TECHNICAL SERVICE BULLETIN

Pop/Sizzle/Crack Noise From Exhaust

21-2109

Ford 2020 Transit

Figure 1

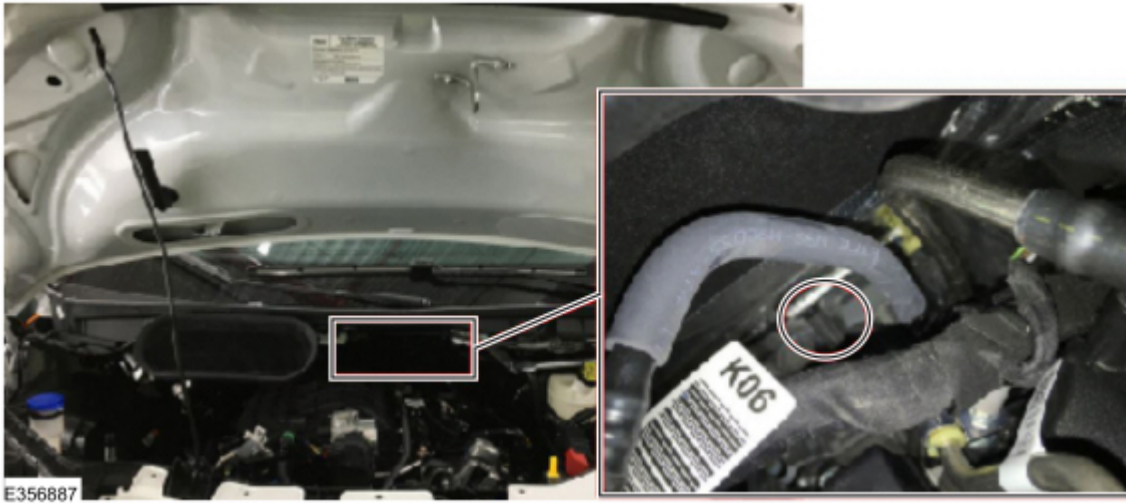
Issue: Some 2020 Transit vehicles may experience a pop/sizzle/crack noise from the exhaust. This may be due to water dripping on the exhaust from the evaporator drain tube. To correct the condition, follow the Service Procedure to extend the length of the evaporator drain tube.

1. Apply a thin coat of Motorcraft® Seam Sealer (Black) to the inside of one end of a locally acquired vinyl tube measuring 5 cm (2 in.) long and an inner diameter of 13 mm (1/2 in.).
2. Install the vinyl tube from the top side of the vehicle to the evaporator drain tube. Use a set of pliers to extend reach if necessary. (Figure 1)
